RCF 20-01
February 20, 2020

NRC License CX-22, Docket Number 50-225.

Supplemental Information Needed for Acceptance of the Application for a License Amendment Re Modification to the Restricted and Exclusion Areas for the Renewed Facility License No. CX-22

**SUPPLEMENTAL INFORMATION NEEDED FOR ACCEPTANCE OF THE
APPLICATION FOR A LICENSE AMENDMENT RE MODIFICATION TO THE
RESTRICTED AND EXCLUSION AREAS FOR THE RENEWED FACILITY LICENSE
NO. CX-22**

Figure 1: Sample Locations Relative to Old Site Fencing

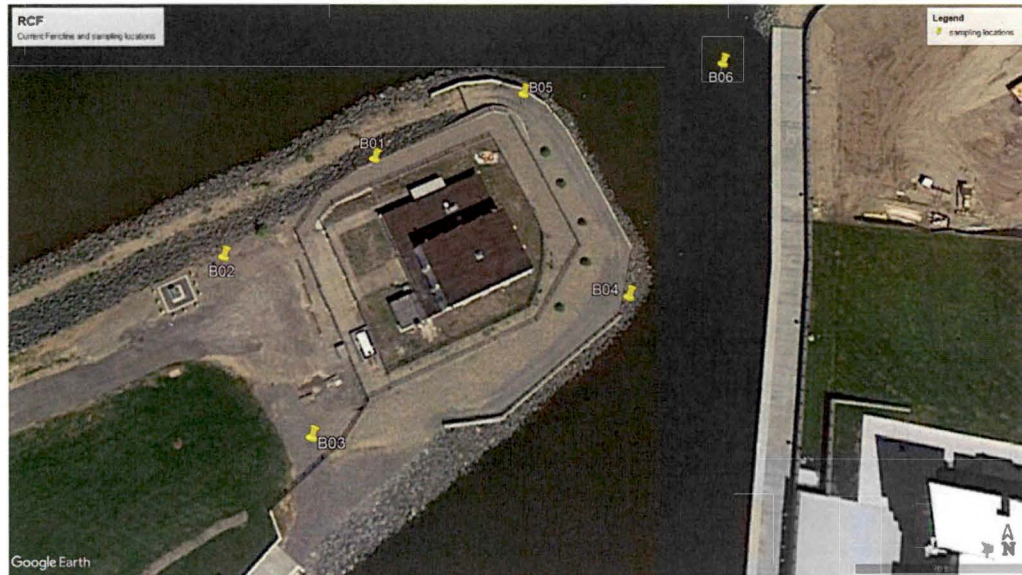
- 1) Provide a detailed description of a) what has been changed regarding the restricted and exclusion areas, not just the numerical number changes; b) the scale of the areas lost due to the construction around the facility; and c) environmental impacts for those lost areas.

A drawing prepared by Hershberg and Hershberg Consulting Engineers is attached with this document as **Appendix 1**. The drawing shows both the locations of the old fence and the locations of the new fence on the same drawing. Old fence is shown by red lines with overlaid “x” symbols. They are also labeled using text and arrows. Also shown on the drawing are the locations of the six core samples, B01 – B06. Figure 1 below shows the sample locations relative to the old fencing in a satellite image. Figure 2 superimposes the sample locations on a photograph of the new site arrangement.

The results of the soil samples are presented in the following section.

Figure 3: Exterior Survey Map

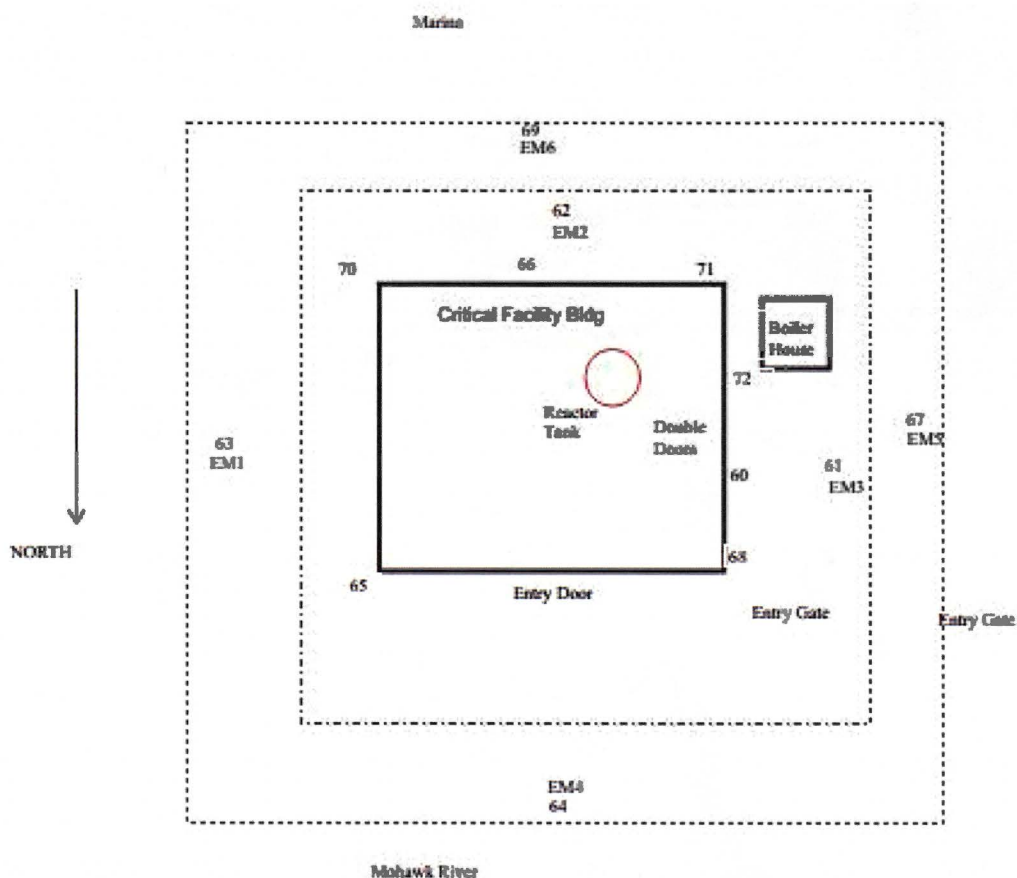
- 2) Provide systematic radiological survey data, including (but not limited to) area exposure rate measurements, soil and ground water samples, etc, to support that there is no significant risk to the public and to the environment from those areas released for unrestricted use.

RPI monitors the external radiation doses with six thermoluminescent detectors (TLD) attached to the inner and outer fences. Figure 3 shows the locations of the TLDs on a schematic.

Radiation surveys on **January 15, 2020** with the reactor operating at ten watts are recorded on Table 2 for locations shown on Figure 3.

Location	Reading, mR/hr
61	0.1
62	0.4
63	0.17
64	0.02
66	1.5
67	0.09
69	0.2
